Date	Expiration	Group	No.	Page
11.2015	11.2016			1(4)

SPOT LIGHTS NOT WORKING 9700 (B13R)

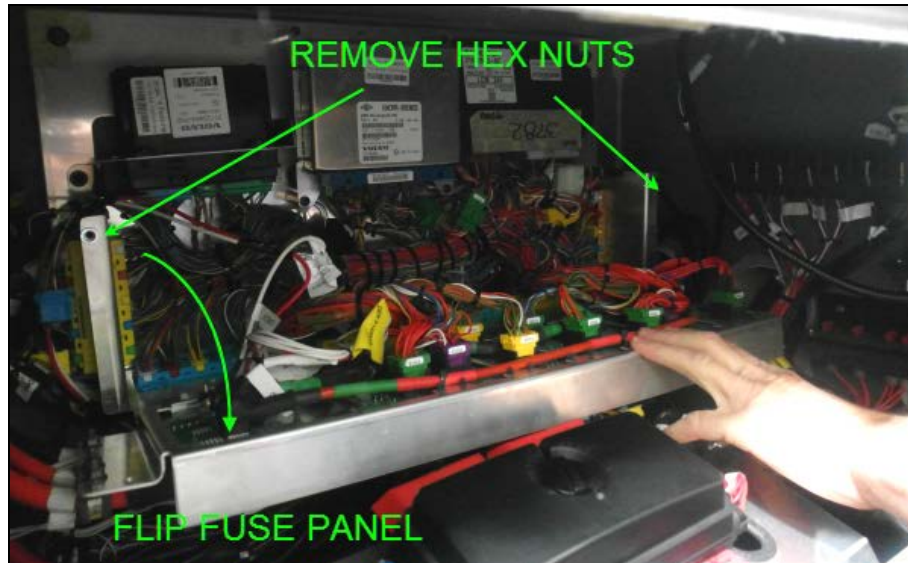
If the spot lights fail to light or they only blink on and go off, the vehicle Lighting Control Module (LCM) harness pin out must be modified as per the drawing below.

Additionally, if the vehicle displays the following codes, harness must also be modified:

- MID 216 PSID 7 FMI 6 Spotlight, current above normal or grounded circuit.
- MID 216 PSID 91 FMI 5 Extra main beam, current below normal or open circuit.

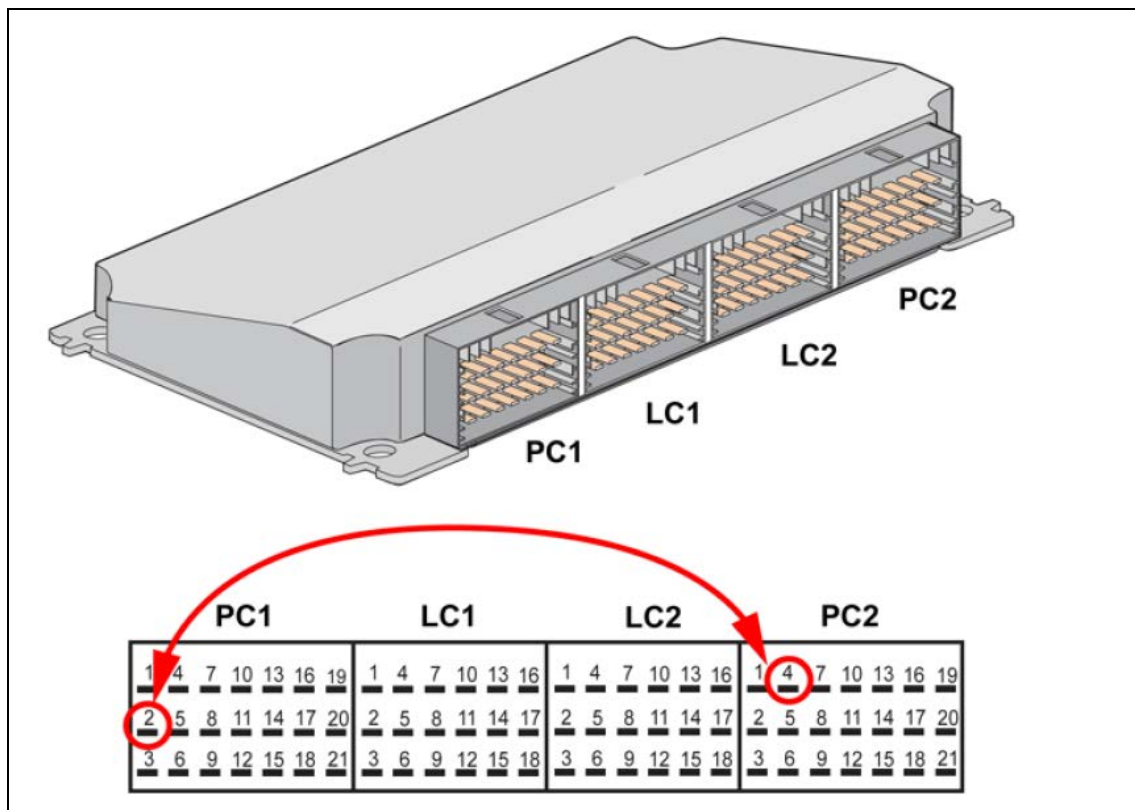
- 3) Switch circuit A27:A2 and A27:D4 in the harness connector (pin PC1_2 and PC2_4 in the harness connector as shown below). Use extractor #88890029 or suitable equivalent tool to remove the terminals from the connector housing without damaging them.

Disconnect and switch pins, **complete with all wires** from one location to another. Do not cut wires to switch from pin to pin.
